UNITED STATES
NUCLEAR REGULATORY COMMISSION

SUBJECT: PRE-LICENSING SITE VISIT - SPRINGFIELD PHARMACY
SOLUTIONS, INC., SPRINGFIELD, MISSOURI

PURPOSE OF VISIT: To discuss the Springfield Pharmacy Solutions, Inc. application for
a new nuclear pharmacy NRC license and evaluate the adequacy
of the proposed facility and radiation safety equipment.

Attachment A

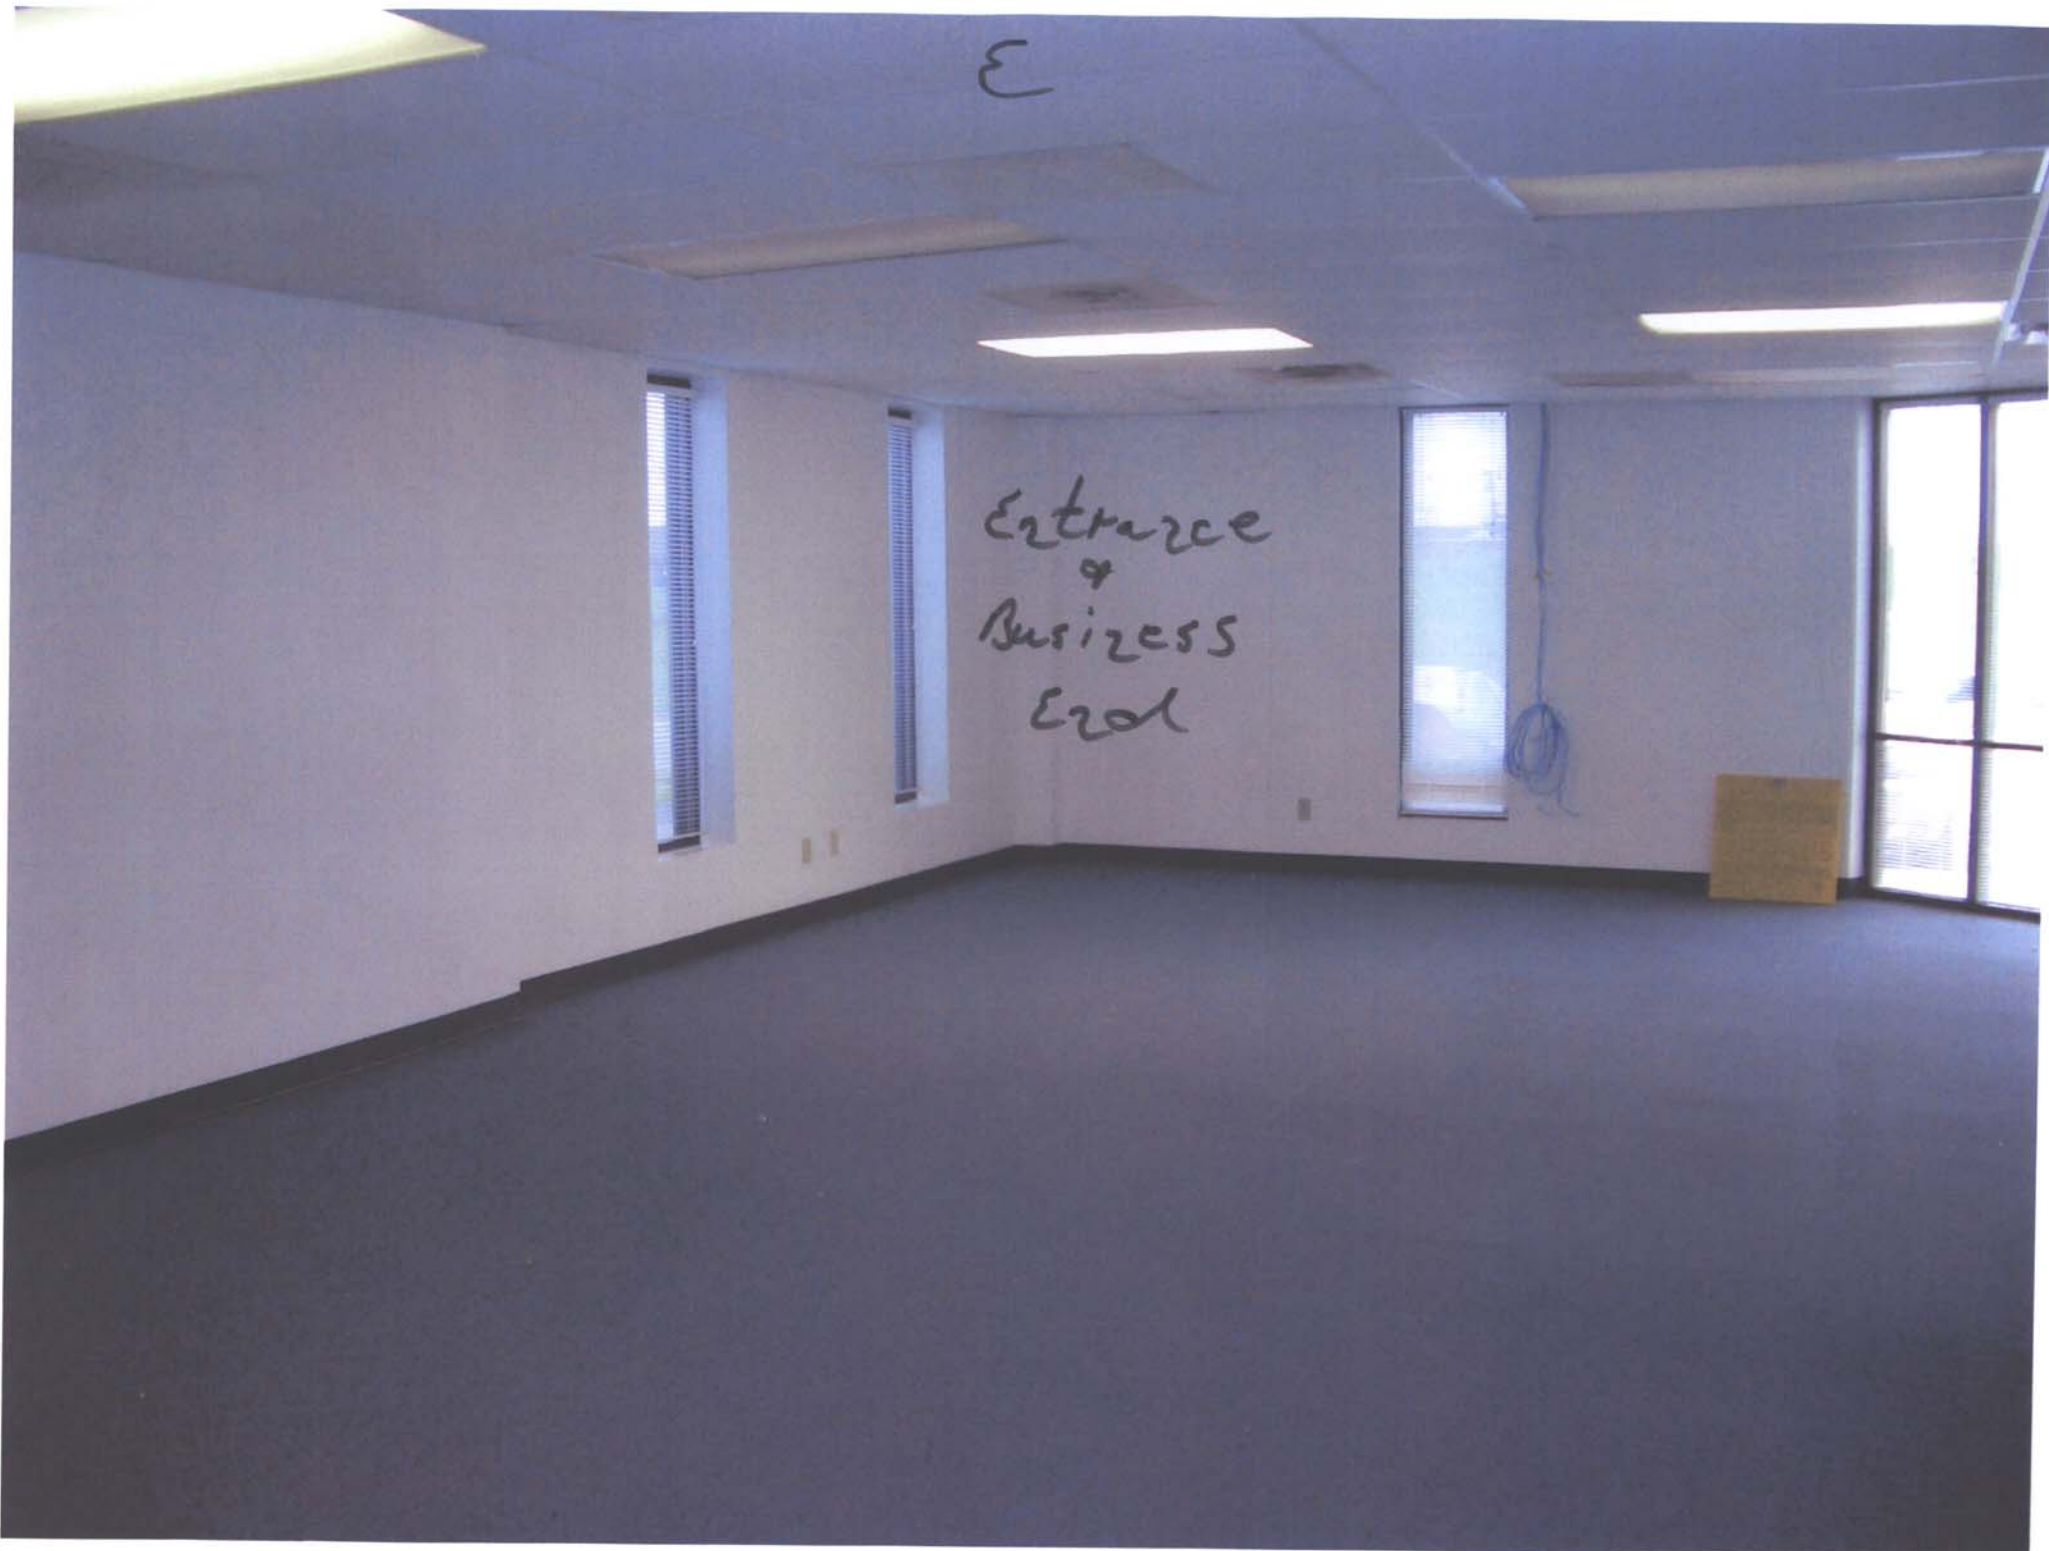
The reviewer noticed a large window in the area of the proposed hot laboratory (see attachments H and I). The reviewer discussed with the PRSO his concern that the window could pose a security problem. The PRSO agreed that the window could pose a potential security problem and indicated that bars or other security measures would be taken prior to the start of licensed activity.

The proposed facility layout appeared adequate from a structural and safety perspective for nuclear pharmacy operations. The alarm system and hot lab window issues will be addressed by the applicant prior to the Missouri State Board of Pharmacy inspection. The NRC nuclear pharmacy license will be issued after the Missouri State Board of Pharmacy has issued its pharmacy license.
